FIELD CHANGE ORDER

NUMBER: DS-650Q5-F001

PROBLEM & SYMPTOM: Cross-talk problem between Dispatcher cable and switched cable. Revision incompatibility problem between M7764-00 and M7763-00 module
(See Page 3 for more details.)

MIRA MicroVAX 3000 (also called MIRA 3200) shipped before 03-JULY-1989 with the following part numbers require this FCO.

INTERCONNECTION OF MIRA MODULES (SYSTEM A only is shown)

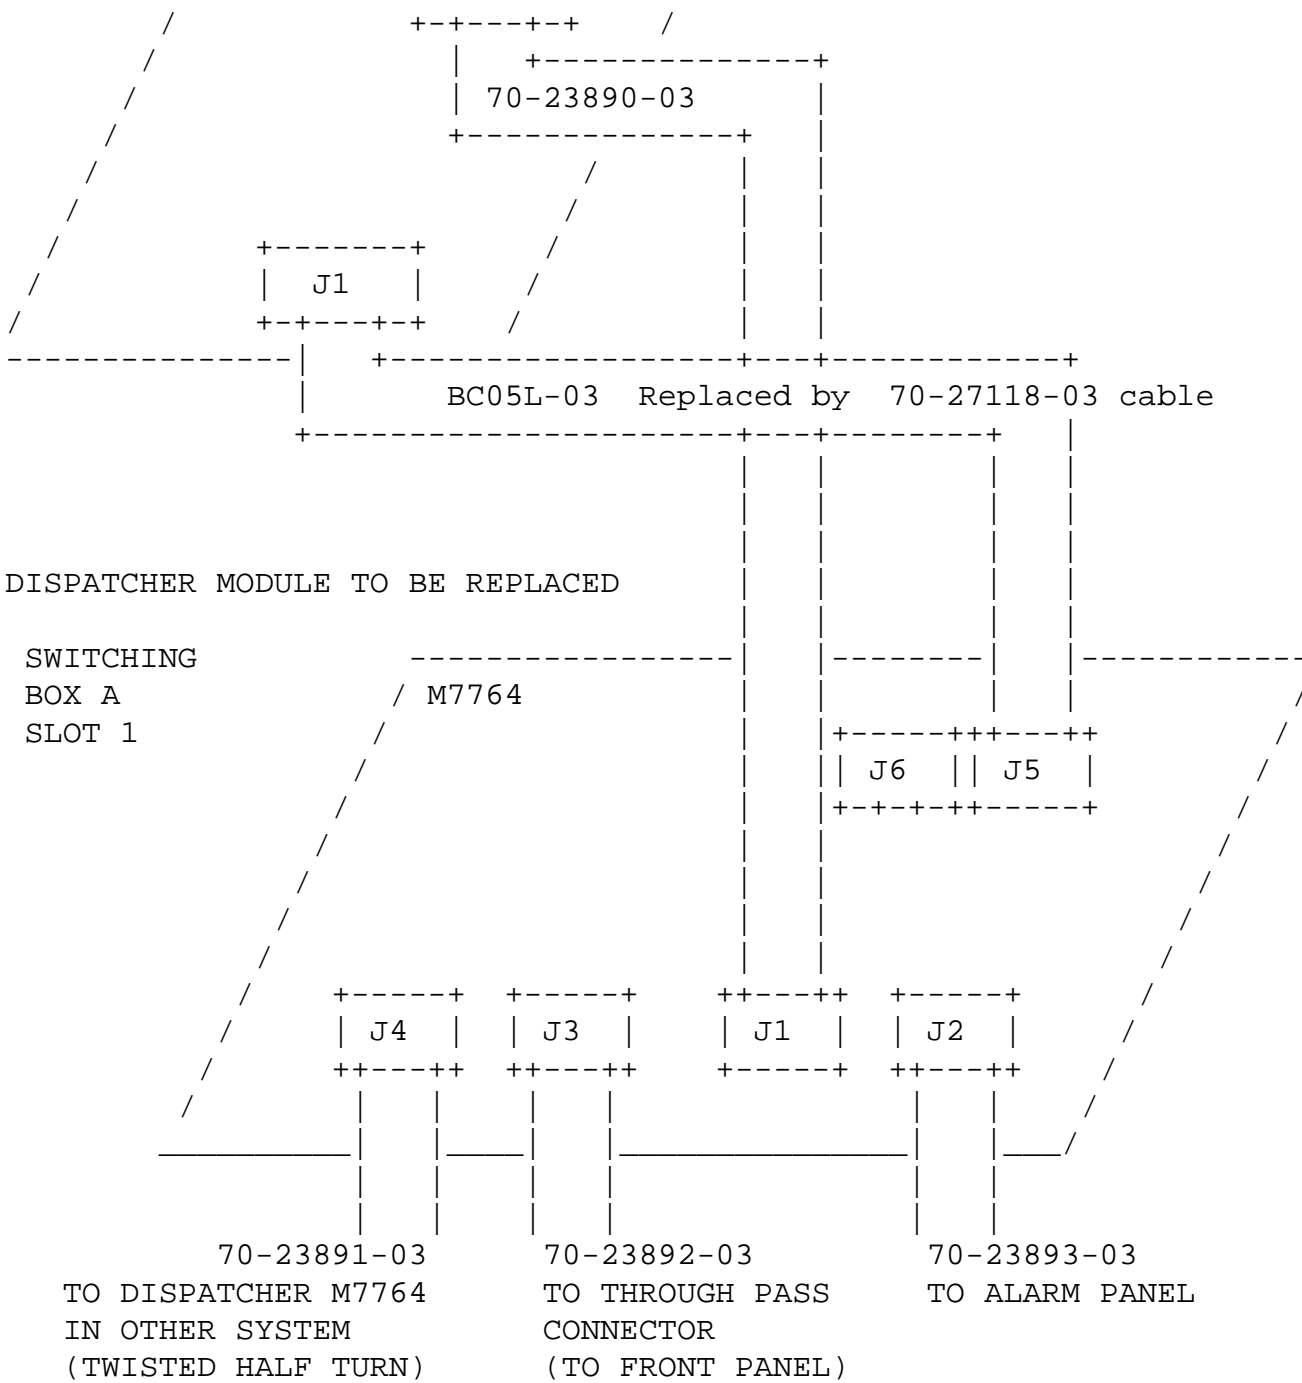
Intermittent data corruptions happen when testing switched KMV1A with MDM Diagnostics in MIRA Systems. The data was corrupted by cross-talk between cables generated by the BC05L cable between the MIRA watch-dog Module (M7763-00) and the dispatcher module (M7764-00).

A re-layout of the two modules M7763-00 and M7764-00 has been necessary to adapt the impedances between these modules. Both M7764 and M7763 become Revision E with the new etch. A new cable 70-27118 has been designed to replace the BC05L cable.

WATCH DOG MODULE TO BE REPLACED

Replace all M7763 and M7764 modules at Revision D or below by new modules at Rev. E and replace BC05L dispatcher cables at one time.

The interconnection of the modules and cables to be replaced is shown on Page 4.
